# Safety Evaluation Report

Renewal of the Facility Operating License for the  
Board of Regents of the University of California,  
University of California, Irvine Nuclear Reactor  
Facility

License No. R-116  
Docket No. 50-326

July 2016

**Figure 1 UCI Reactor Organization Chart**

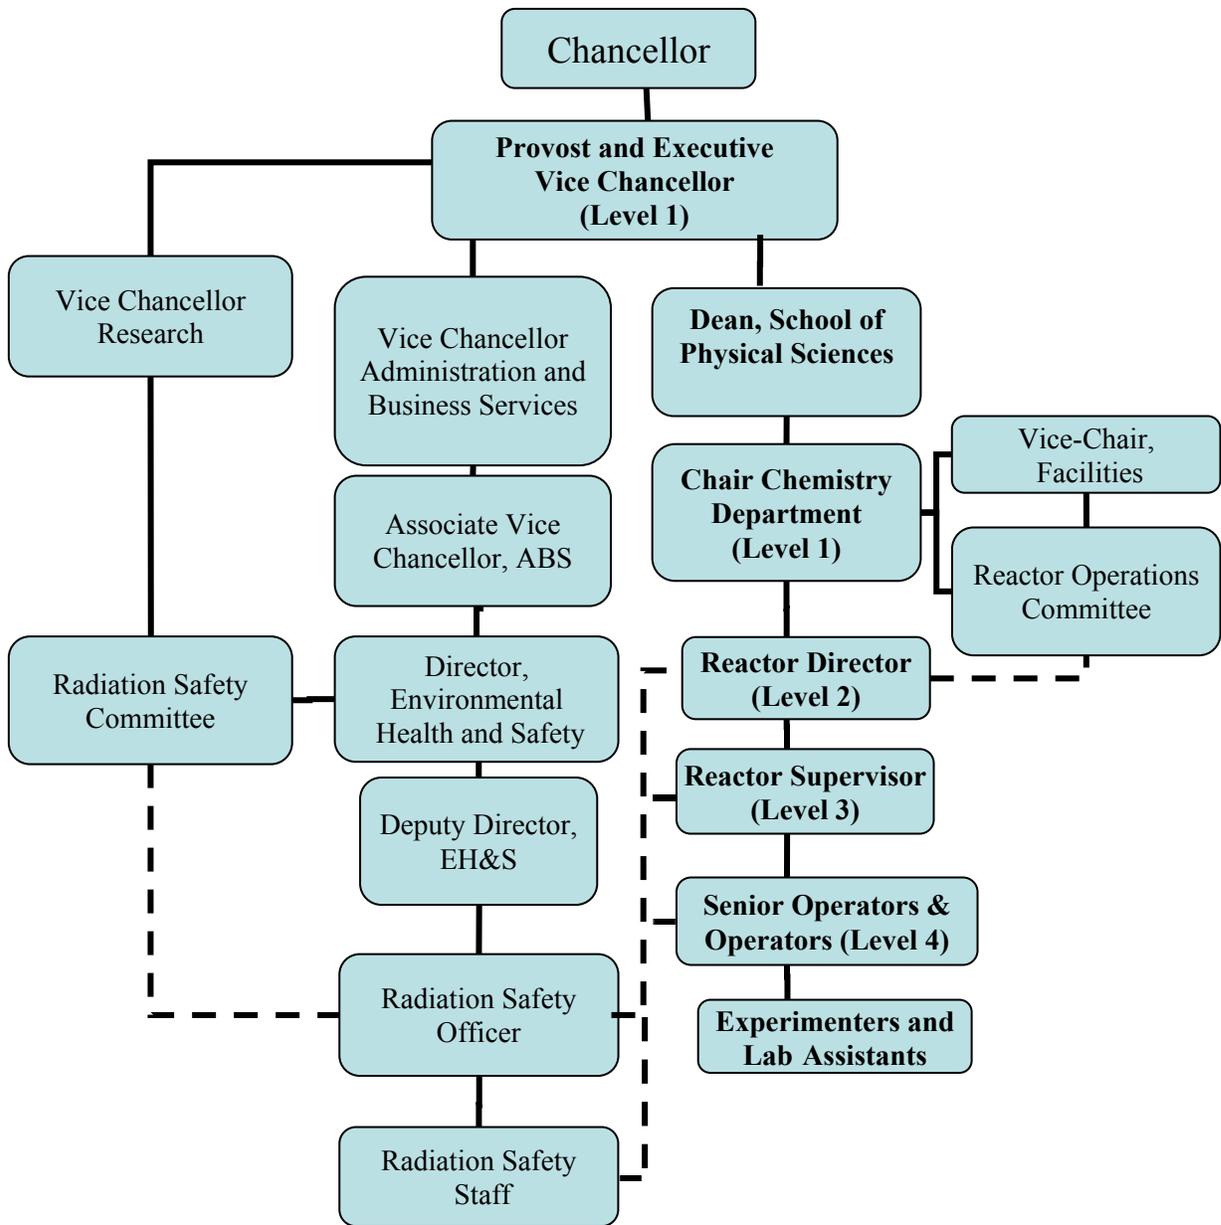
TS 6.1.1 ensures that the UCINRF organization structure is delineated, as described in TS 6.1.1, Figure 1. The NRC staff reviewed TS 6.1.1, Figure 1, and finds that Figure 1 identifies the reporting and communication relationships between the organizational units for the UCINRF and is consistent with the guidance provided in NUREG-1537 and ANSI/ANS-15.1-2007. On

the basis of the information provided above, the NRC staff concludes that TS 6.1.1 and TS 6.1.1, Figure 1 are acceptable.
